Barangaroo Headland Park and Northern Cove - Main Works

Response to submission (Transport and Traffic)

7 February 2011

Prepared for
Barangaroo Delivery Authority

Figure B1 – Cruise Terminal Peak Period Traffic Flows

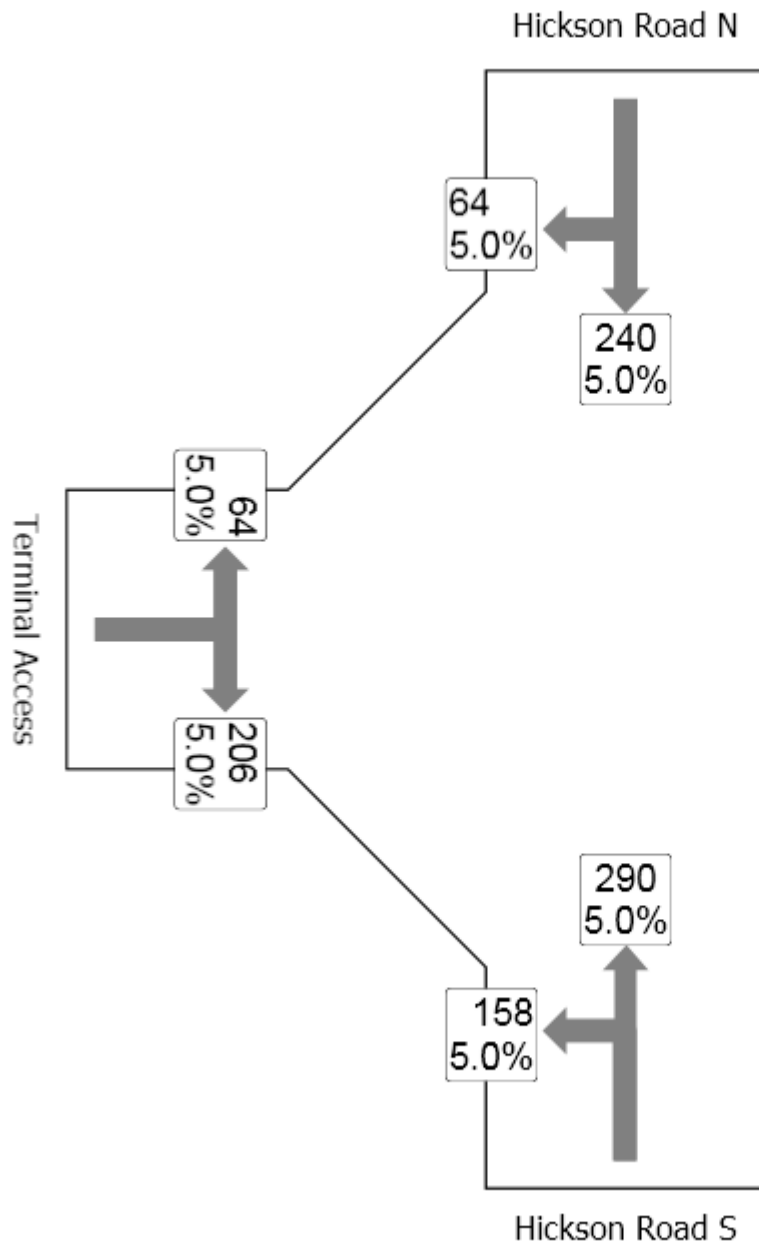
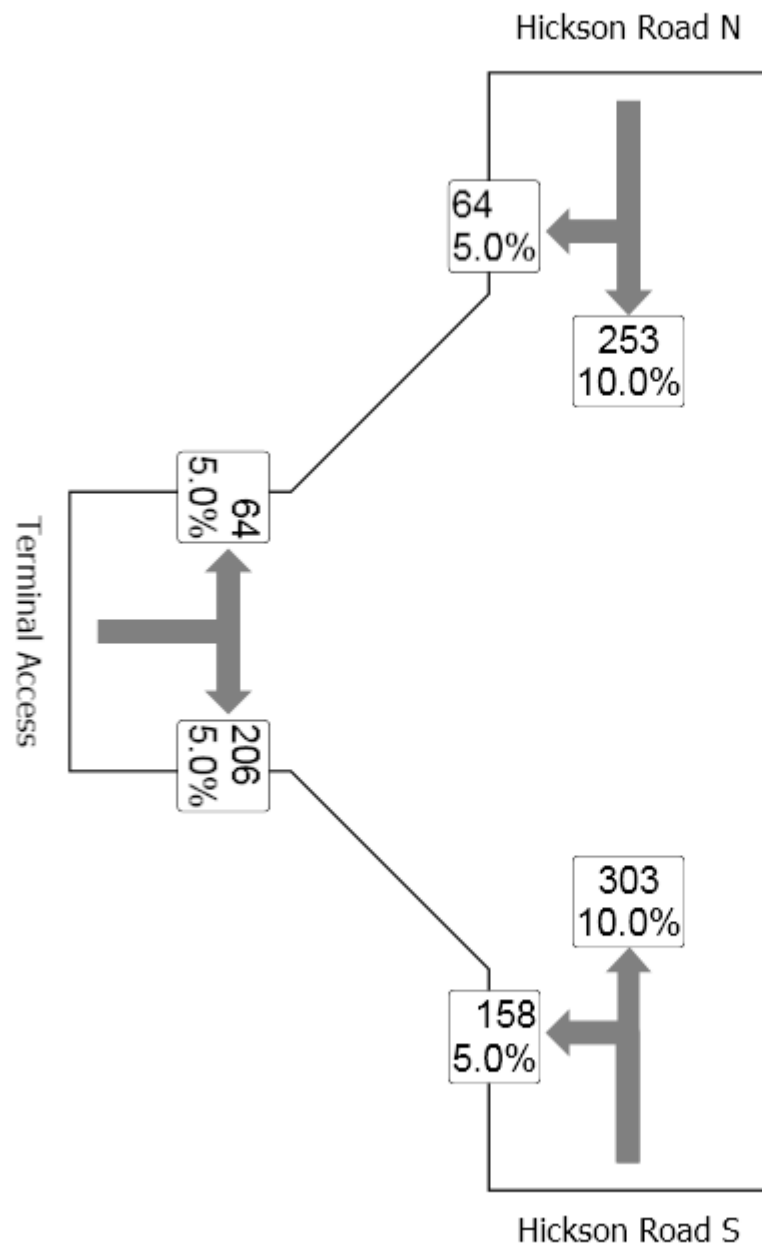
Assess potential impacts on the operation of temporary cruise passenger terminal at Wharf 5 Hickson Road.

The analysis was based on a count of traffic using Hickson Road with peak hourly cruise terminal traffic added. The period analysed was that during the middle of the day when cruise terminal traffic generation would be highest. The traffic flows used in the analysis are provided in Figure B1 to this report.

Results of this analysis are provided in Figure B2. In summary, traffic along Hickson Road including that turning into the site would operate well with little or no delay, both with and without the Headland Park construction traffic being present.

The analysis allows for only one lane coming out of the terminal. In practice better performance would be achieved if the section of its exit into Hickson Road at Gate 5 was marked as separate left and right turn lanes. This treatment is recommended.
